UNITED STATES
NUCLEAR REGULATORY COMMISSION
WASHINGTON, D. C. 20555

Docket Nos. 50-259
50-260
and 50-296

RE: ACCEPTANCE CRITERIA FOR THE MARK I CONTAINMENT LONG TERM PROGRAM

NRC ACCEPTANCE CRITERIA
FOR THE
MARK I CONTAINMENT
LONG TERM PROGRAM

Figure 2.10-3 Impact and Steady Drag Force Correlation for Type 2 Deflector

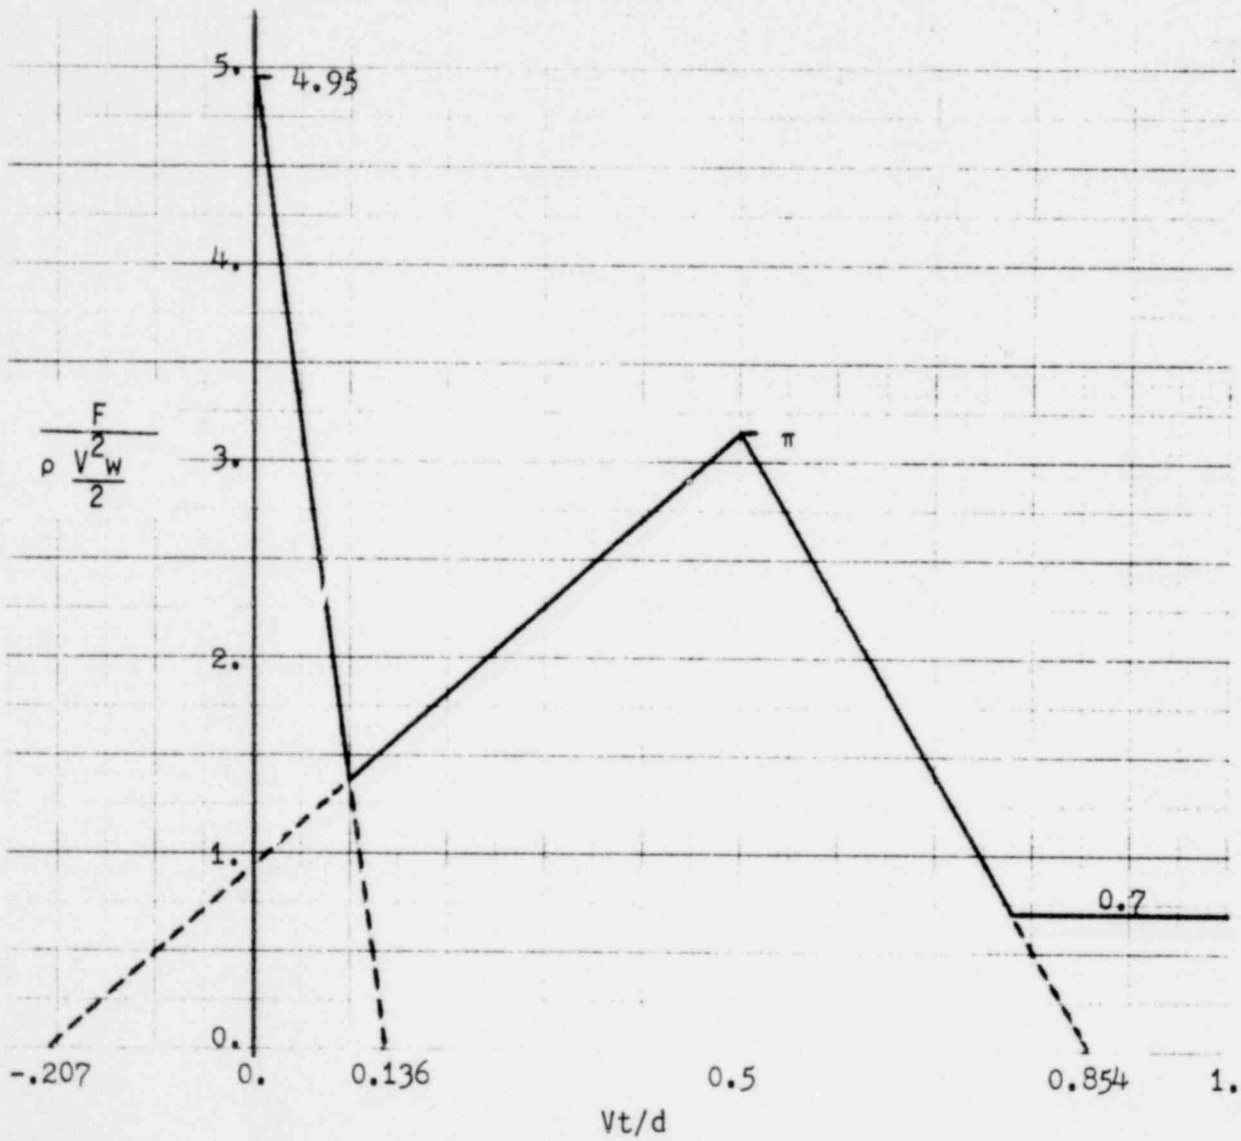
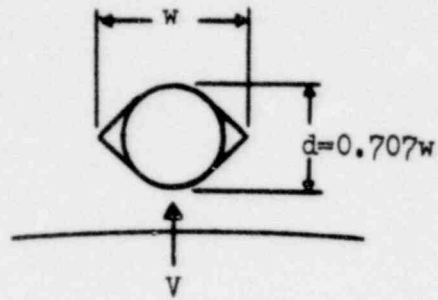
1. The impact transient and "steady drag" contributions to the load shall be computed from the correlations shown on Figures 2.10-2 through 2.10-5, for deflector types 1 - 4, respectively. For times past the periods shown, the last value shall be extended for the duration of the transient.
2. The three-dimensional load variation and timing shall be based on the EPRI "main vent orifice" tests, as discussed in Section 2.5.
3. The gravitational component of the acceleration drag shall be included in F_A , as defined in NEDO-24612.
4. In computing the deflector response to the load, the added mass of the water shall be accounted for, as described in Section 2.10.1.3 above.
